Project	IEEE 802.16 Broadband Wireless Access Working Group < http://ieee802.org/16 >
Title	Amendment to EAP Security Primitives in 14.2.2.1
Date Submitted	2007-03-1408
Source(s)	Jung-Mo Moon, Jee_Hyeon Na, Mi-Young Yun, and Sangho Lee jhna@etri.re.kr ETRI 161 Gajeong-dong, Yuseong-gu Daejeon 305-700 Korea
Re:	Contribution on comments to IEEE 802.16g/D8
Abstract	Re-definition of EAP primitives in 14.2.2.1
Purpose	Adoption
Notice	This document has been prepared to assist IEEE 802.16. It is offered as a basis for discussion and is not binding on the contributing individual(s) or organization(s). The material in this document is subject to change in form and content after further study. The contributor(s) reserve(s) the right to add, amend or withdraw material contained herein.
Release	The contributor grants a free, irrevocable license to the IEEE to incorporate text contained in this contribution, and any modifications thereof, in the creation of an IEEE Standards publication; to copyright in the IEEE's name any IEEE Standards publication even though it may include portions of this contribution; and at the IEEE's sole discretion to permit others to reproduce in whole or in part the r

Figure 473 – EAP based Authentication Procedure

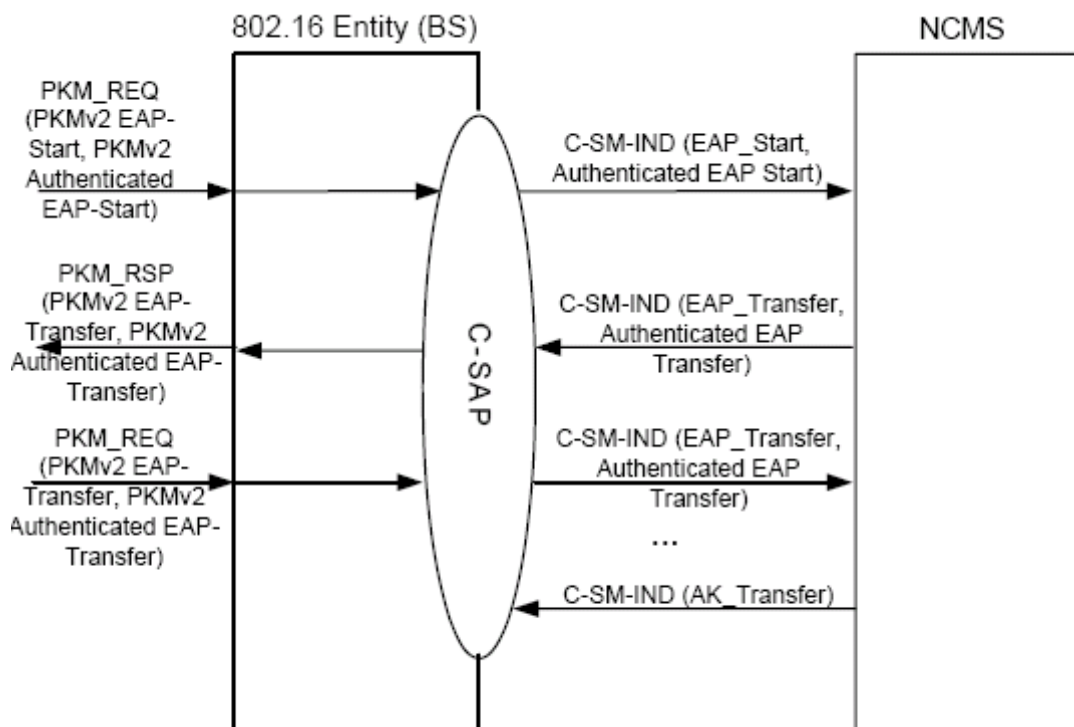
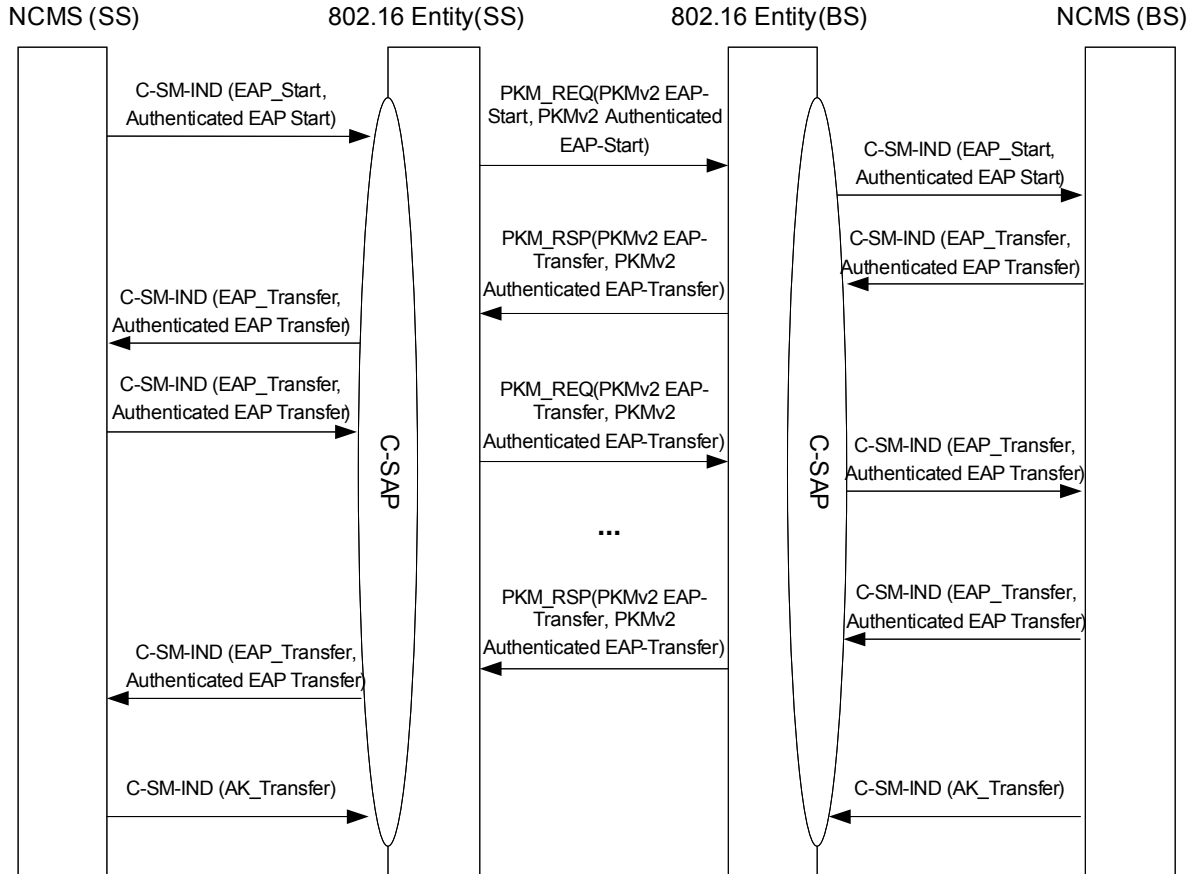
1. Modification of figure 473 to illustrate EAP-based security primitives on SS side.
2. Modification of each subsection to clarify and describe on each side (SS and BS side)

Figure 473 shows EAP-based authentication procedures between an BS-802.16 entity and an NCMS on SS and BS sides and an AAA Services entity in NCMS as follows:
